Report: TAB Report
Function: Test, Adjust, & Balance
Date: 01/21/2026
Completed By: National TAB

01-12-26 Wawa #7402 Indianapolis, IN

Project: 01-12-26 Wawa #7402 Indianapolis, IN

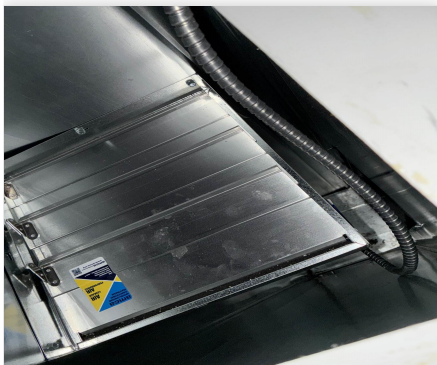
Issue Name : EF-1 BACKDRAFT
Description : EF-1 backdraft damper too small for ductwork. This impedes TAB as it reduces total airflow. Potentially related to over-amp issue.
Created By : National TAB **Assigned To :** National TAB - Noah Stafford
Status : Open
Priority : Urgent **Asset Tag :**
Originated Date : 01/12/2026 - Noah Stafford - National TAB

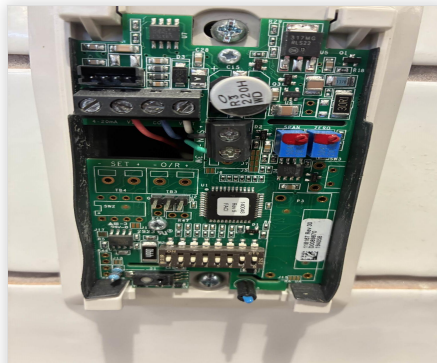
Issue Name : RTU SENSOR WIRING
Description : RTUs use only thermostat wiring for the sensors. Design plans call for twisted pair shielded cables containing 18AWG minimum. This issue does not prevent TAB.
Created By : National TAB **Assigned To :** National TAB - Noah Stafford
Status : Open
Priority : Medium **Asset Tag :**
Originated Date : 01/12/2026 - Noah Stafford - National TAB
